**RE: St MATTHEWS CATHOLIC COLLEGE, MUDGEE (SSD 9872)
CORNER BROADHEAD ROAD AND BRUCE ROAD, SPRING FLAT (MUDGEE)
POST RESPONSE TO SUBMISSIONS – REQUEST FOR ADDITIONAL INFORMATION**

I write on behalf of Trustees of the Roman Catholic Church for the Diocese of Bathurst in relation to the current SSD DA for the new St Matthews Catholic College – Secondary Campus at the corner of Broadhead Road and Bruce Road, Spring Flat (Mudgee) and provide a response to requests for further information arising from our Response to Submissions package of early October 2020.

Figure 8.2: Future Vehicle Trip Distribution

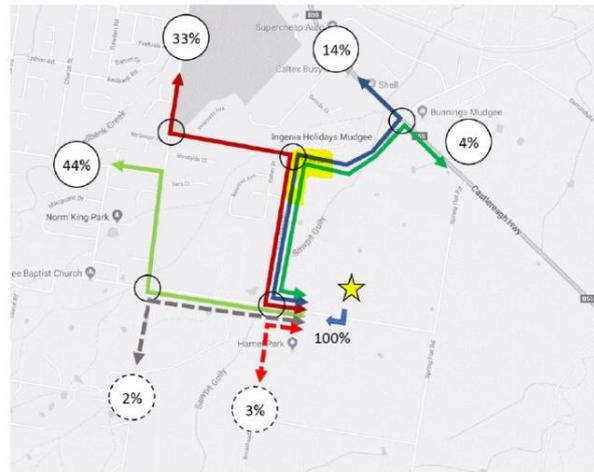
<p><u>Broadhead Road / Lions Drive</u> It is likely / possible that greater than 4% of vehicles exiting the School using Broadhead Road may wish to turn right at Lions Drive. Broadhead Road may require widening to provide for left and right turn lanes to avoid congestion and excessive queuing.</p>	<p>Broadhead Road / Lions Drive The Broadhead Road / Lions Drive intersection has been discussed extensively with Council and agreed would be upgraded to suit required swept paths for the school bus route along with suitable treatment methods for longevity. This latest request for widening and addition of lanes is not supported by the traffic modelling.</p>
<p><u>Robertson Street / Lions Drive</u> This is a T-intersection with Robertson Street as the through road. There is potential for a significant proportion of traffic (including existing traffic not associated with the school) exiting Lions Drive wishing to turn left to access Spring Road which provides alternative access to other areas of Mudgee South. This may also require some widening of Lions Drive to provide for left and right turn lanes. (Note: Existing pavement width might allow for turning lane definitions using line-marking only but further detailed survey and design would be required).</p>	<p>Note, also Council’s acceptance of the extent of Broadhead Road roadworks as set out immediately above in the first comment by Council on the submitted RtS – as quoted below:</p>

<p><u>Robertson Road / Bruce Road</u> This intersection is a crossroad with Bruce Road through this intersection having an offset alignment. There is no kerb and gutter on any of the pavements and the pavement will require some upgrade prior to line-marking and installation of signage.</p>	<p>Road Upgrades – Broadhead Road <i>Council confirms that the proposed road upgrades as outlined in the EIS and RtS are satisfactory. As per Council’s EIS submission and normal Council practice, it is requested that the final design and detailed drawings are approved by Council prior to commencement of road upgrade works.</i></p>
<p>The revised SIDRA modelling provided indicates that 12% of vehicle access will use Bruce Road east of school and Spring Flat Road. This would suggest that sealing of this road beyond the school abuttal and extending to Spring Flat Road is warranted.</p>	<p>With further respect to the Broadhead / Lions intersection and to confirm, the traffic assessment considers a traffic split of 18% (14% plus 4%) (not the 4% quoted by Council) turning right from Broadhead Road south approach to Lions Drive east approach as shown / highlighted below (Figure 8.2 of the TIA).</p>

The SIDRA modelling results indicate that the intersection would operate at a Level of Service 'A' in all future scenarios. In the scenario with the highest traffic flows (Scenario 4), the average delay and queue lengths are minor for both the left-turn and right-turn movements. Screenshots are provided further below showing the SIDRA modelling outputs for this intersection in Scenario 4 – it shows an average queue length of 1m i.e. less than one vehicle. Specifically, for the right turn movement, the model considers 24 vehicles (AM peak) and 17 vehicles (PM peak) which corresponds with the 18% right-turn split as mentioned above.
